Access Compliance Report Public Rights-of-Way (Curb Ramps)

Intersection ID: 43483 Main Street: PRIDELAND CT **Cross Street: ERWIN_RD** Location: NW ADA ID: 45078622B6C5 Ramp Type: PerpDiag Initial Pass/Fail: Fail **Overall Compliance: No** Severity Score: 13.75

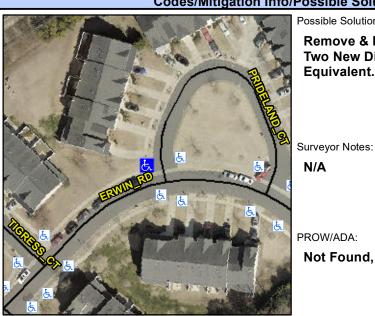
Not Found, R304.2.2, R304.5.3

| Fleid Measurements/Component Compilance | | | | | |
|---|-----------------------|------|------------------------|-----------------------------|------|
| N/A | Ramp Length (in) | 47.0 | No | Ramp Slope (%) | 10.1 |
| Yes | Ramp Width (in) | 48.0 | No | Ramp XSlope (%) | 2.2 |

ERWIN RD None **PRIDELAND CT** StopSign Possible Solutions: Remove & Replace Curb Ramp With Two New Directional Ramps or Equivalent.
